Pediment

07/10/09 AT 174.8
KATELYN SCHWARTZ
JOHN WINTER

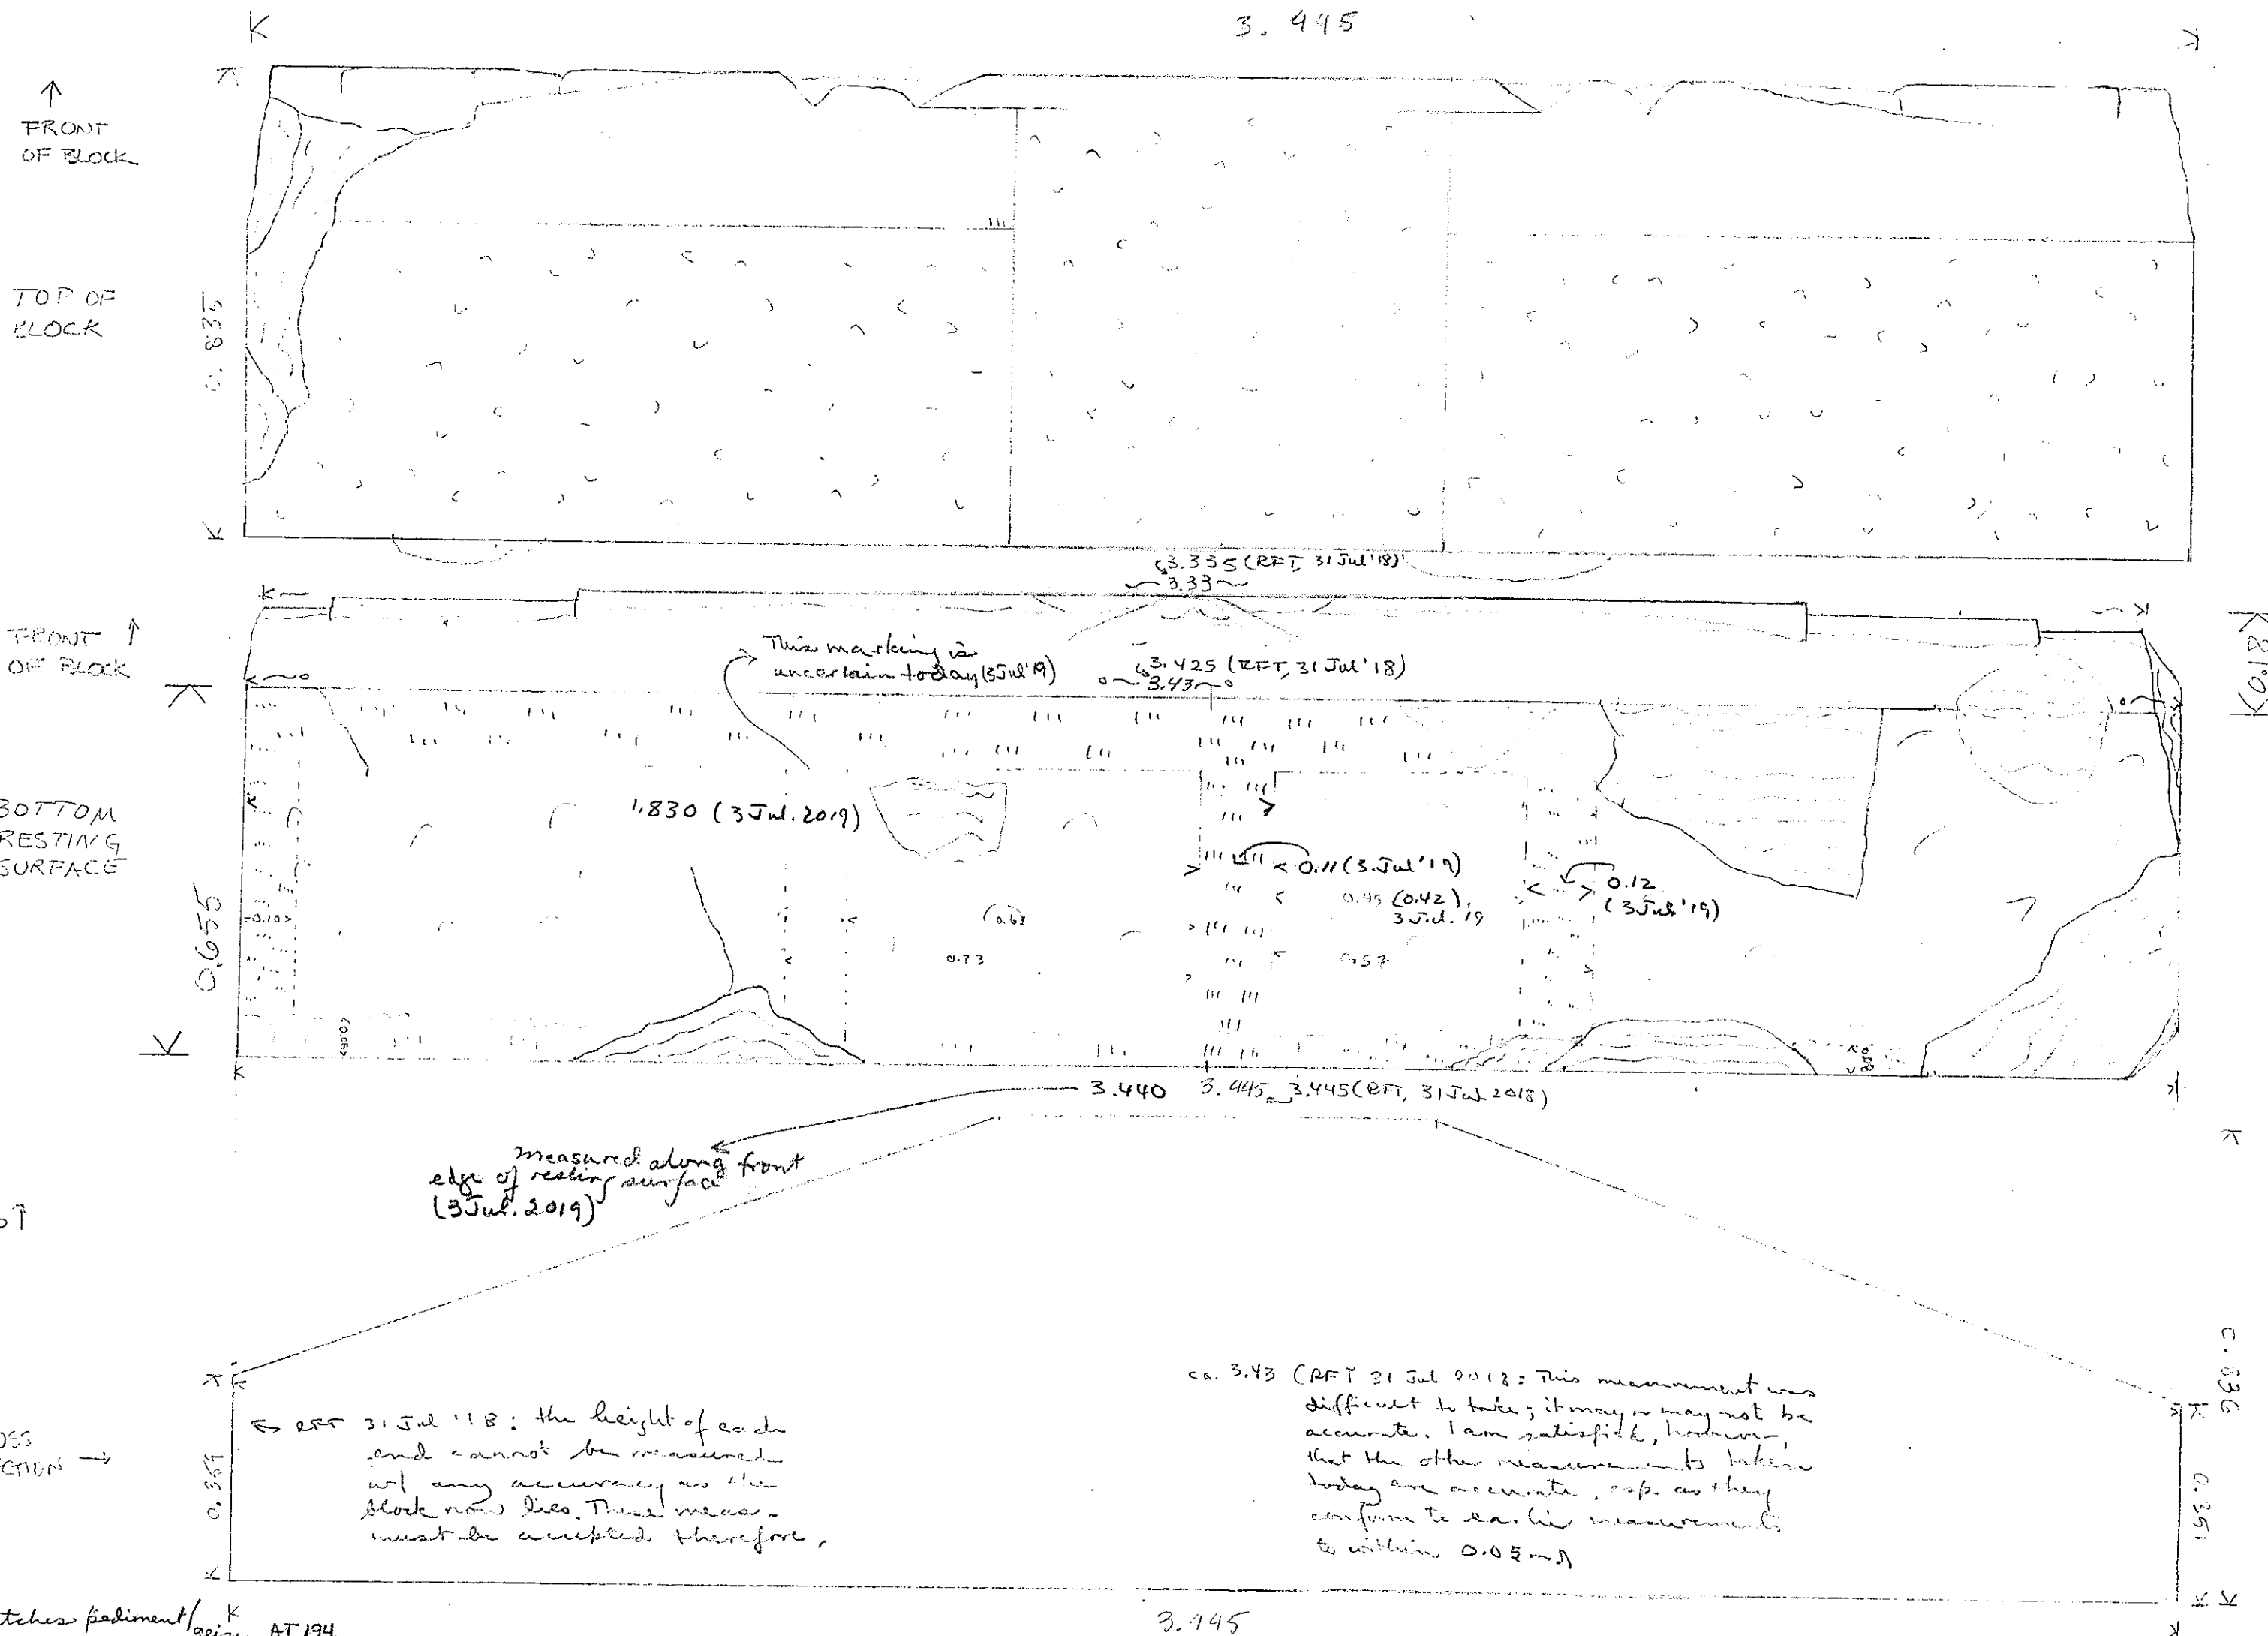
Degree of slope of pediment as indicated by the cross-section matches that of AT 289, a fragmentary block of the pedimental gable, front on which base preserves the slope of the pediment. It also matches pediment given AT 194.

Further note: remeasurement

of ht. of pediment block at left and (as one faces front of block) production a ht. of 0.380 as opposed to either 0.357 (actually drawn as 0.361) or 0.351. I have not calculated how much this would affect the slope.

Finally, it is not clear which end of the pediment is which in the cross-section since it is not oriented correctly with the rest of the drawing.

Given the fact that the cross-section AT 289, and AT 194 all match closely, I am going to assume the measurement given on the cross-section should be used rather than mine of 0.380.
